**REPLACEMENT OF QUARRY ROAD BRIDGE
SUFFIELD, CT
ADDENDUM NO. 1
March 26, 2025**

1. Sign in sheet for mandatory pre-bid meeting held on March 20, 2025.
(4 pages)
2. Pre-Bid Meeting Agenda
(1 page)
3. Responses to questions and additional information discussed at the pre-bid meeting.
(1 page)
4. Answers to Questions Received by March 24, 2025.
(1 page)
5. Sheet No. 6 and Sheet No. 8 updated to reflect comment responses.
(2 pages)

CUTOFF WALL ELEVATION
EAST (INLET) CUTOFF WALL AS SHOWN
WEST (OUTLET) CUTOFF WALL MIRROR IMAGE
CAST-IN-PLACE CUTOFF WALL DETAILS
 SCALE: 1/2" = 1'-0"

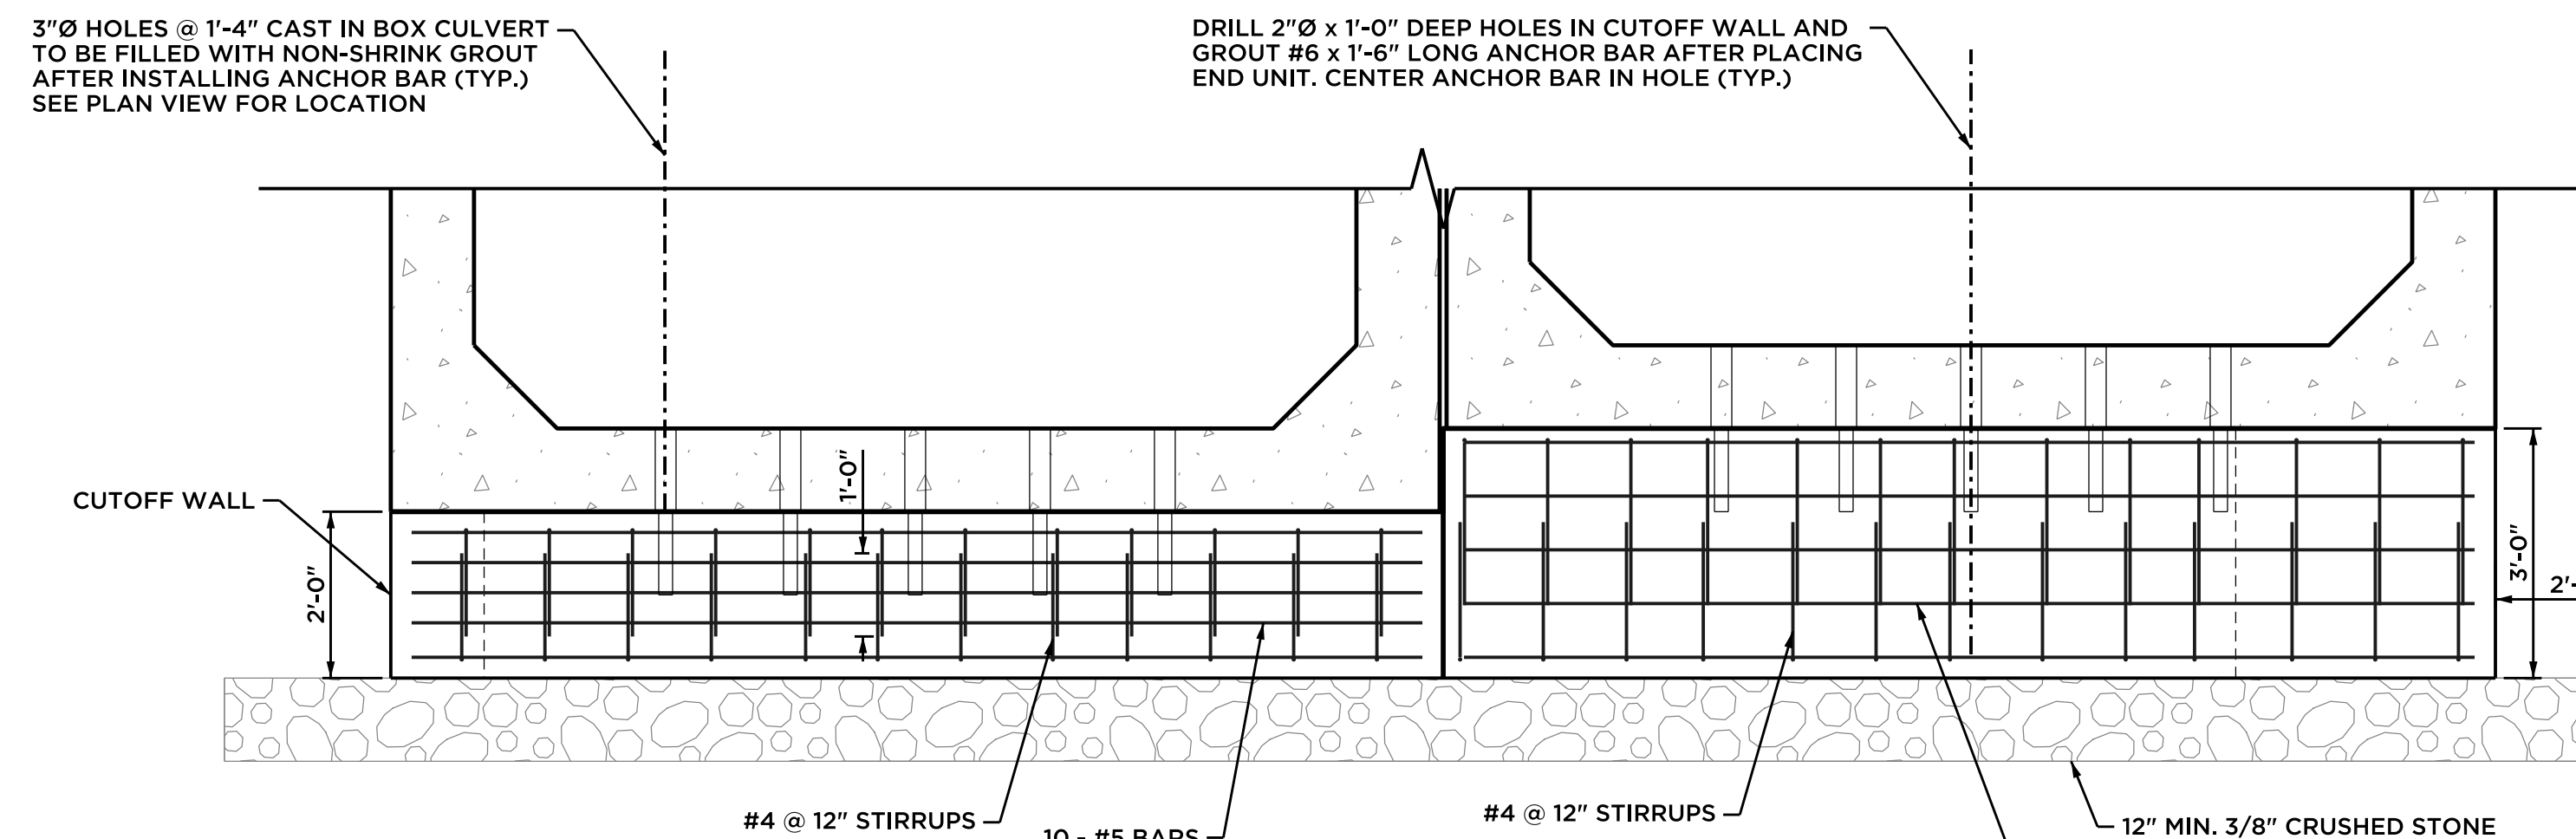
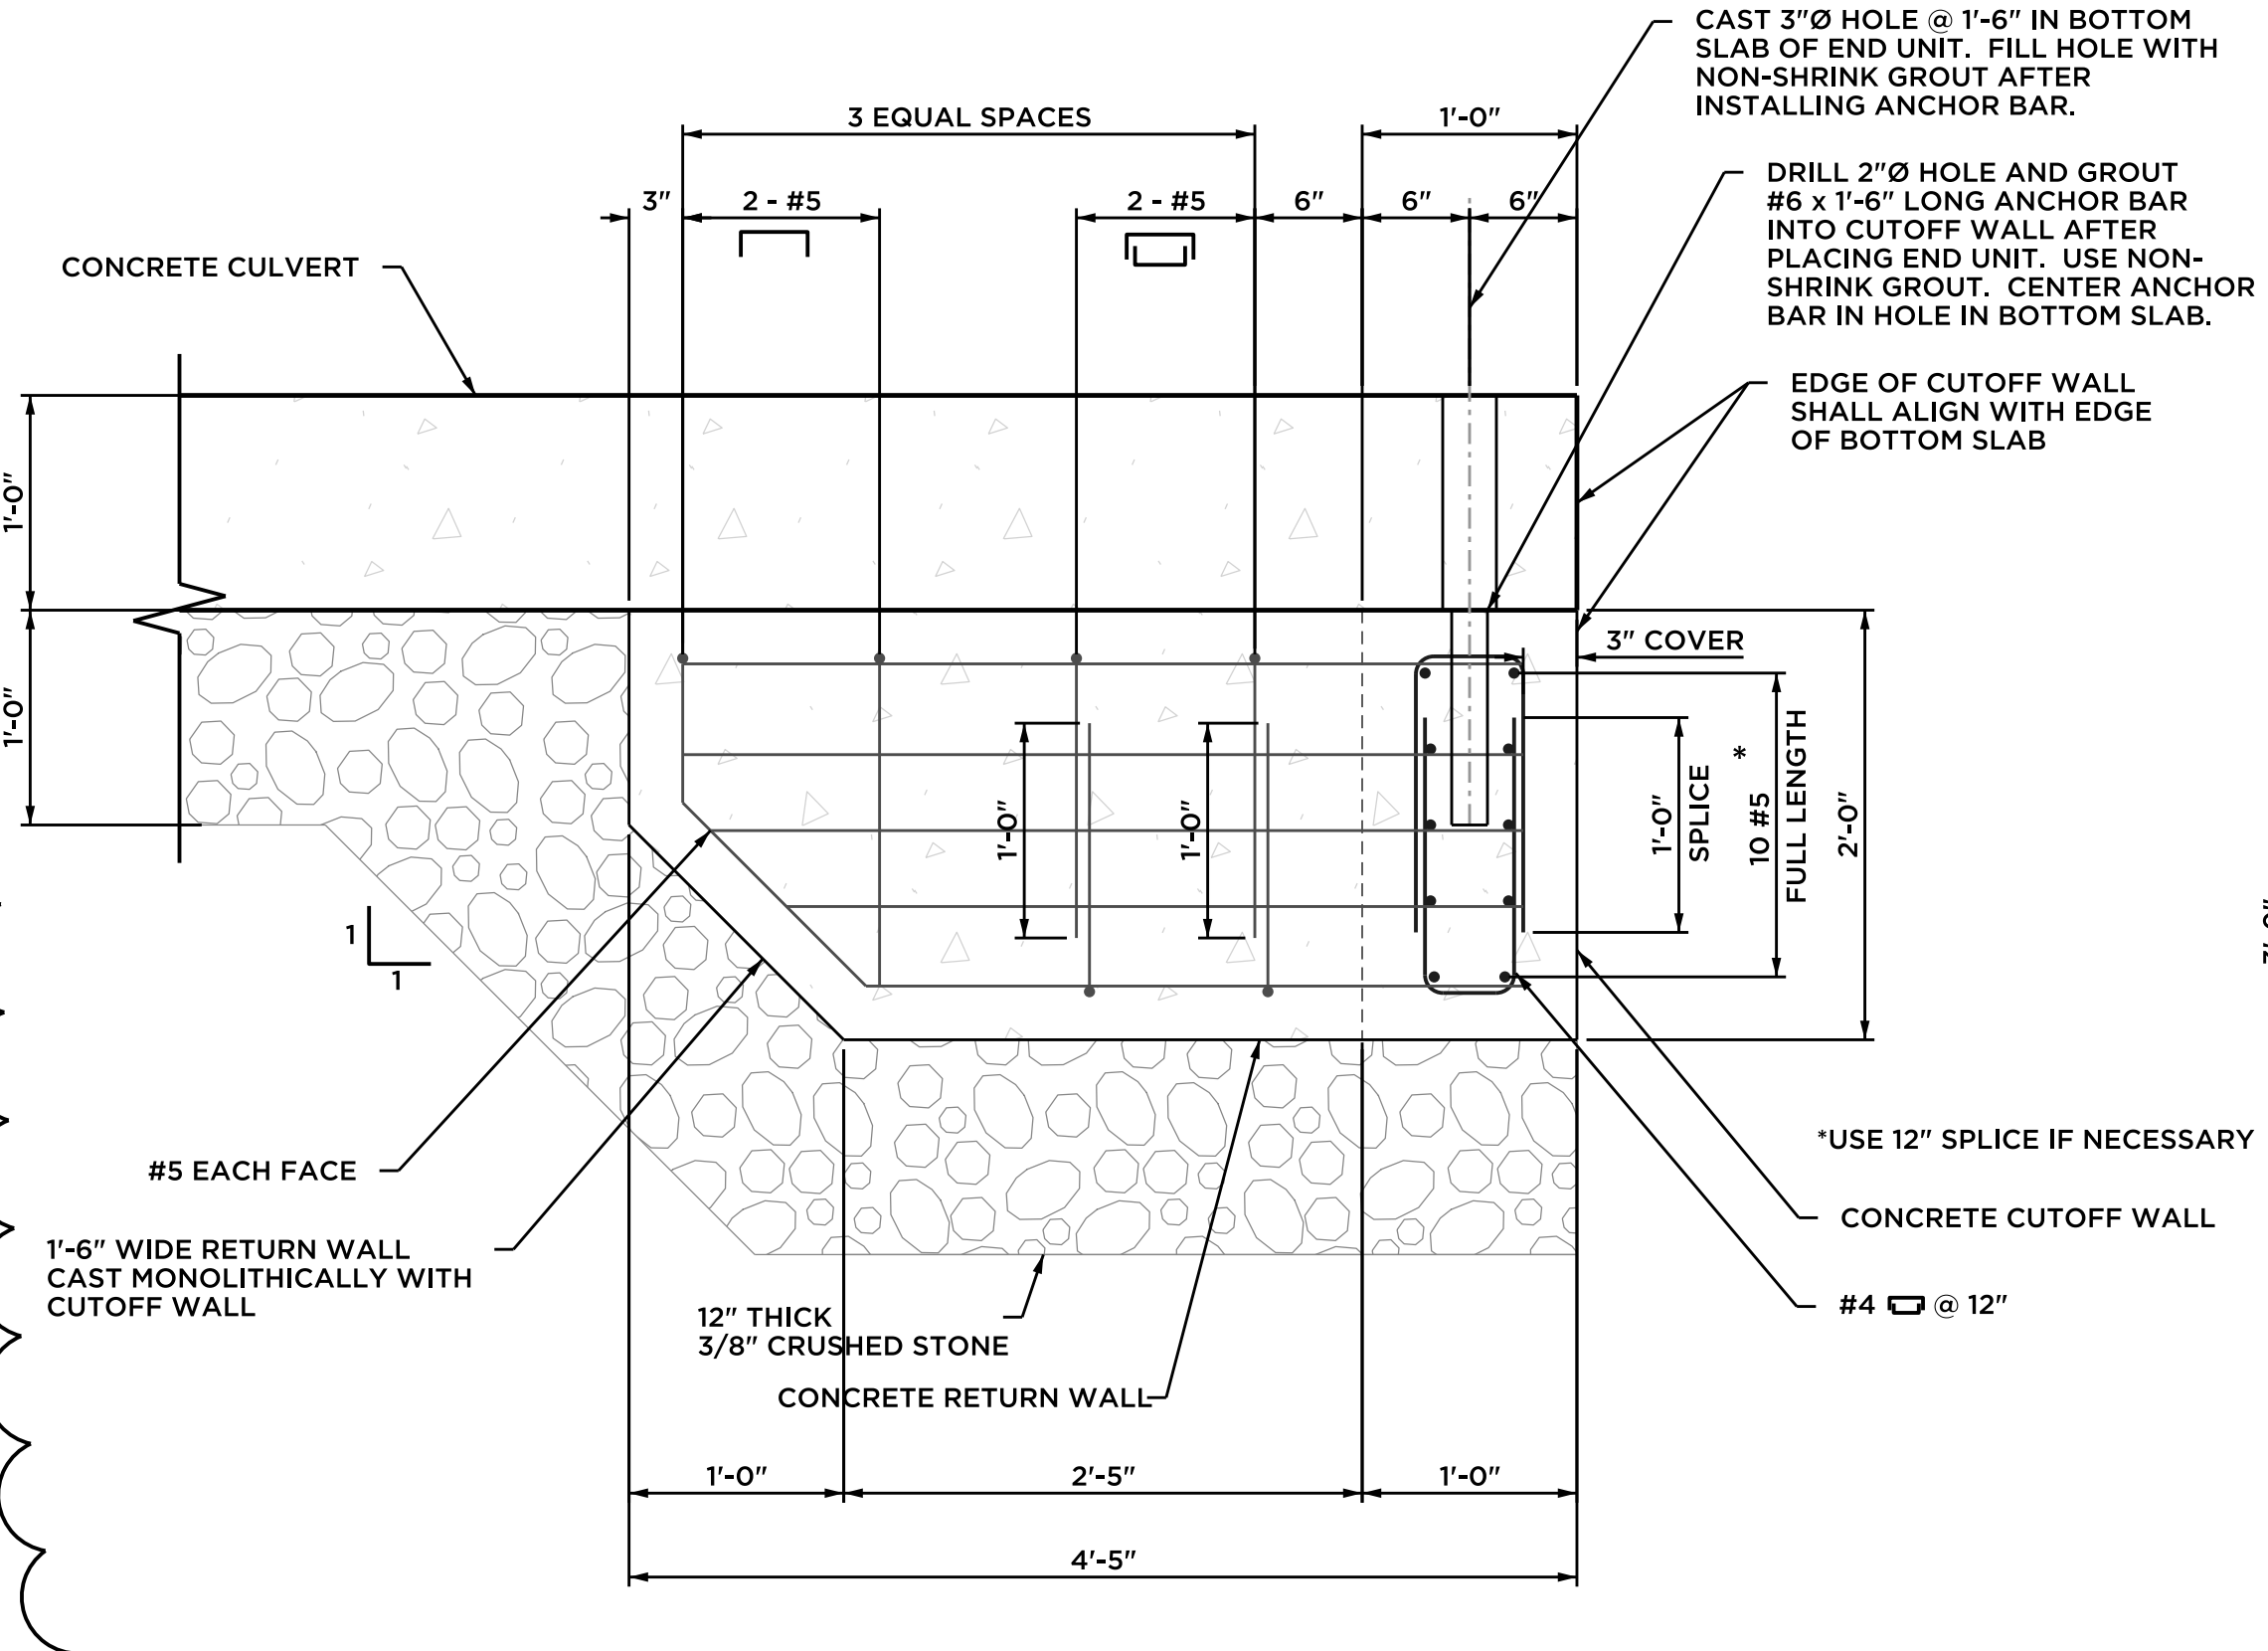
Question - The cutoff walls look to be shown as one complete unit on each end for both culvert runs. Typically these are built as a separate pieces under the end of each run. Then we will cast inserts in the face of each piece for the nosing to be cast-in-place for both the cutoff walls and the faces of the culverts to tie everything together.

Response – Sheet 6 has been updated to show two separate cutoff walls that will have threaded inserts cast into them to connect the nosing footing.
